**TILE ROOF WORKSHEET**

re: Job 98279: CHEW

Subject: Structural Investigation Report of the Roof for the Residence located at 7255 Havenside Drive, Sacramento, CA 95831.

1 ROOF PLAN - CHEM  
 N.T.S.

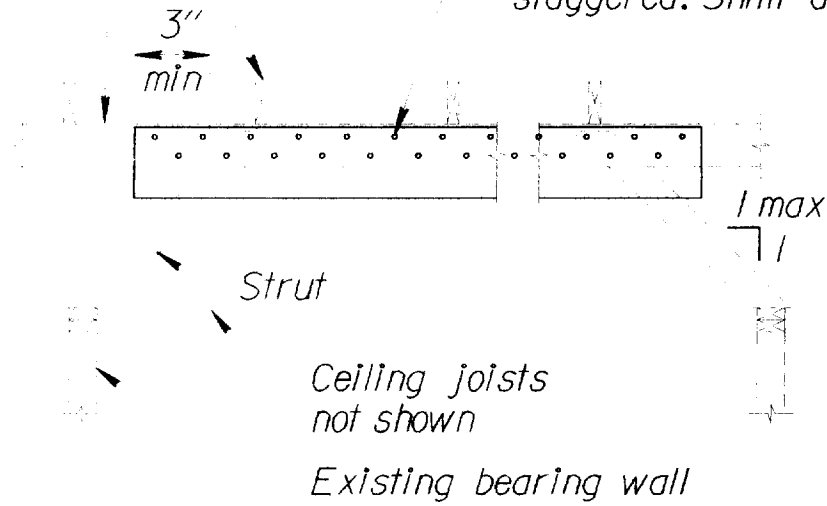
Roof:  
The living and garage areas lack sufficient structural capacity for the applied live and dead loads.

1. Provide additional 2x4 struts from the existing purlins to the bearing walls below. The maximum spacing between the new and existing struts shall not exceed 6'-0" on center and the minimum slope of the struts shall not be less than 45 degrees from the horizontal. See detail 1.
2. Scab a 1 3/4" x 1 1/8" x 22'-0" long microlam purlin to the existing 2x12 purlin which spans 22'-0" (total 2). Attach it with 16d's @ 3" on center. Support the microlam to the bearing walls below with 2x4 struts. See details 1 and 2.
3. Scab a 2x12 DF#2 x 12'-0" long purlin to the existing 2x6 purlin which spans 12'-0". Attach it with 16d's @ 3" on center. Support the 2x12 to the bearing walls below with 2x4 struts. See details 1 and 2.

4. Add 2x8 cross ties as required so that the maximum spacing does not exceed 4'-0" on center. Nail the cross ties to the existing rafters with 6 -16d's at each connection. See detail 1.

SCAB 1 3/4 x 11 7/8 x 22°  
 MICROPOLAM TO EXISTING  
 2x12 x 22° PURLIN  
 (TOTAL 1 @ EACH  
 LOCATION) (2)

SCAB 2x12 x 12° TO EXISTING  
 2x6 PURLINS THAT SPAN 12°  
 ADD 2x4  
 STRUTS (TOTAL 2) (2)

ADD 2x8 CROSSMETS  
 (TOTAL 5)

ADD 2x4 STRUTS  
 (TOTAL 2)
